**SOUTHWEST SHIPYARD, L.P.**

Re: a. **Southwest Shipyard, L.P.**  
**Docket No. 97-0453-IHW-E**  
**Agreed Order, Ordering Provision 2i**

b. **Workplan for Site Assessment of Portions of A, B, and C Yards, prepared by Groundwater Services, Inc. on behalf of Southwest Shipyard, L.P., submitted to TNRCC, October 27, 1997**

**TABLE 1**  
**RESPONSE TO TNRCC COMMENTS ISSUED JANUARY 29, 1998**

### SITE PLAN: BACKGROUND SOIL SAMPLING LOCATIONS

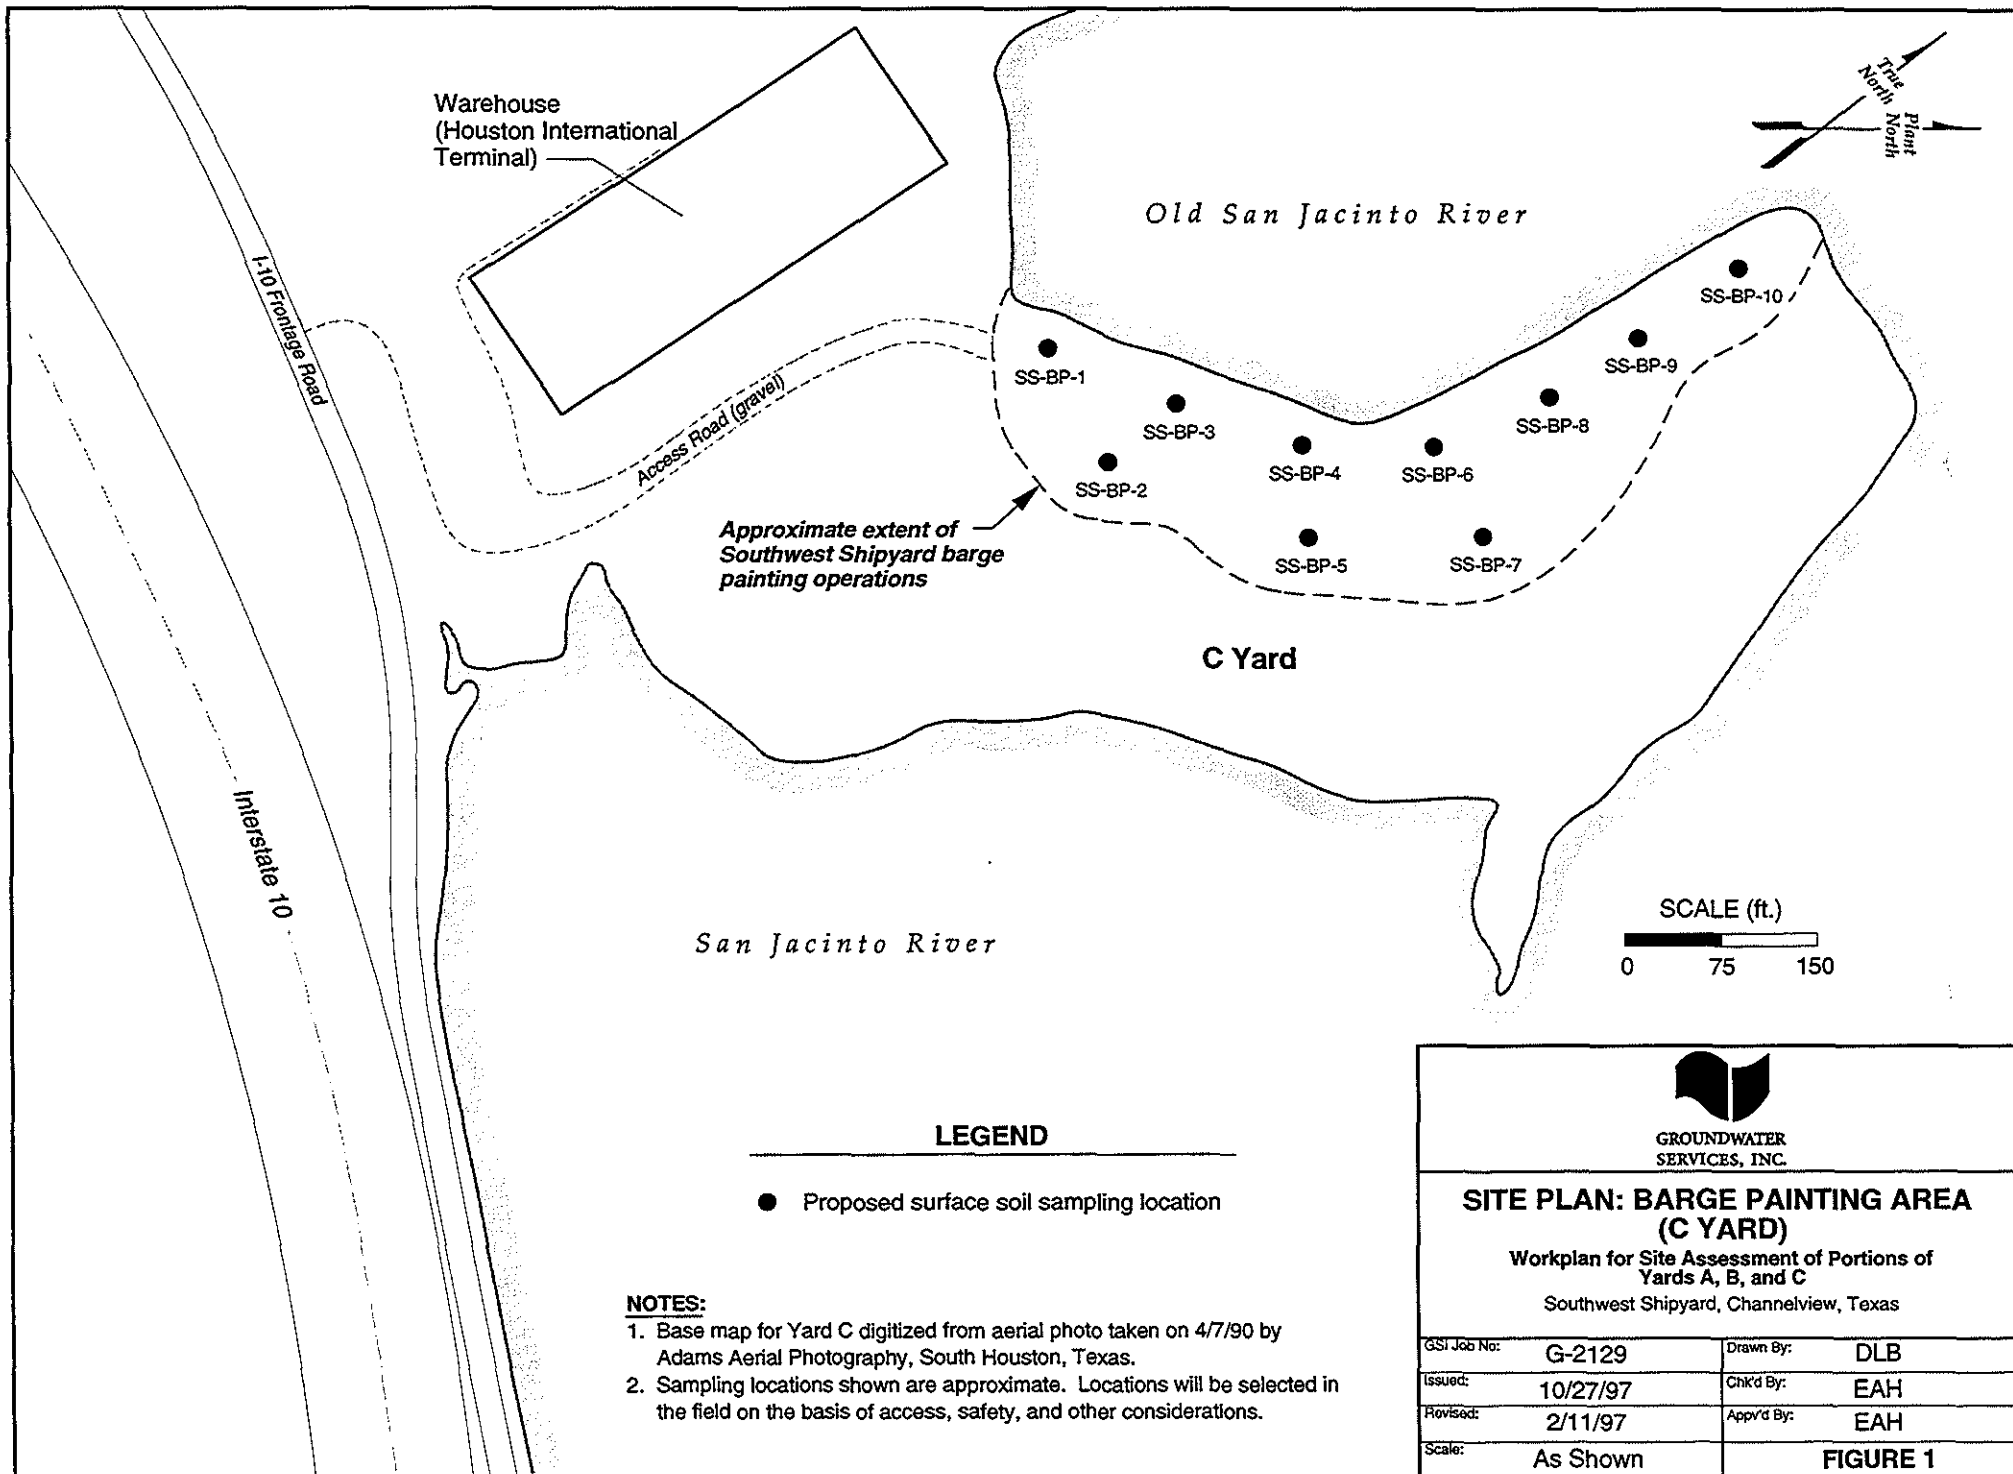
AREA OF CONCERN	TNRCC COMMENT SUMMARY	SOUTHWEST SHIPYARD RESPONSE
Background Metals (A Yard)	1. TNRCC understands that a municipal landfill was previously operated in the area of proposed background soil samples. A different location should be proposed for collection of soil samples used to evaluate background metals concentrations.	• Aerial photographs taken at approximate 5-yr intervals from 1965 to 1996 evidenced no apparent activities associated with a municipal landfill. However, nearly all of the peninsula on which Southwest Shipyard is located has been filled using dredged materials. Fill activities appear to have been minimal in an area immediately adjacent to the entrance road (i.e., north of the previously proposed background locations). Therefore, alternate background soil sampling locations are proposed in this area (see Figure 3).

## SITE PLAN: SHEET METAL DOCK AREA (B YARD)

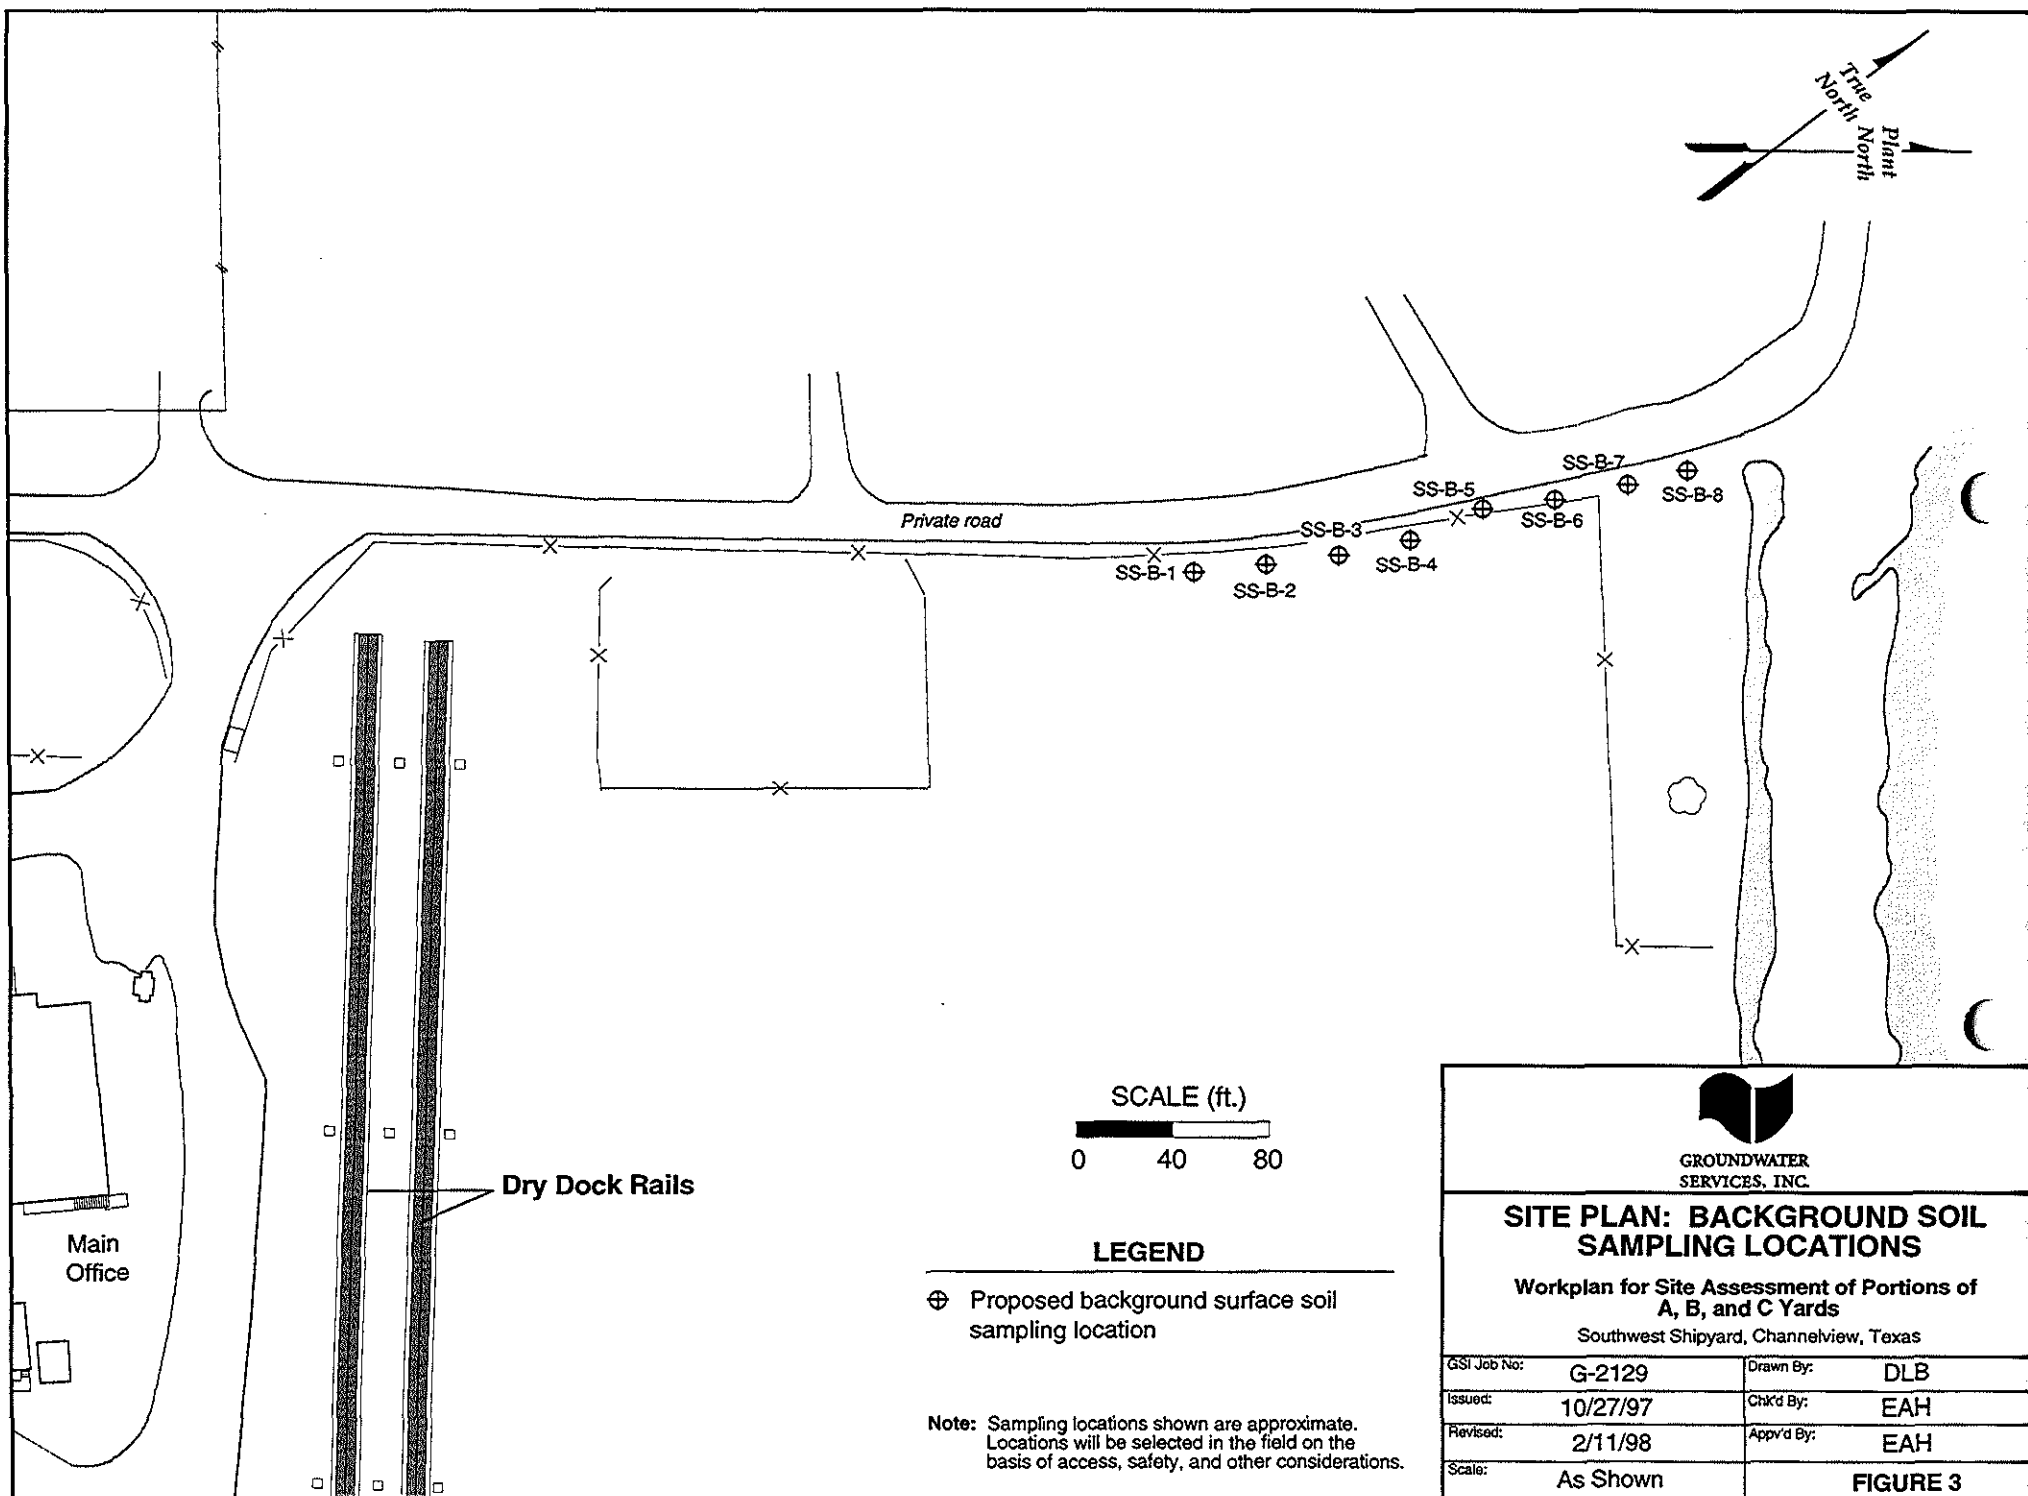
AREA OF CONCERN	TNRCC COMMENT SUMMARY	SOUTHWEST SHIPYARD RESPONSE
Sheet Metal Dock Area (B Yard)	1. Revise the site map for this area to include the following site features: i) office trailer, ii) sand blasting area, iii) two sand hoppers, iv) container storage area, v) road leading to the Sheet Metal Dock area, and vi) paint storage building.	• The site plan has been revised as requested (see Figure 2).

7. Additional soil borings (SS-SM-9 and 10) are requested contingent upon an access agreement between Southwest Shipyard and the property owner of B Yard.	• Southwest Shipyard seeks clarification regarding whether additional soil borings are requested.
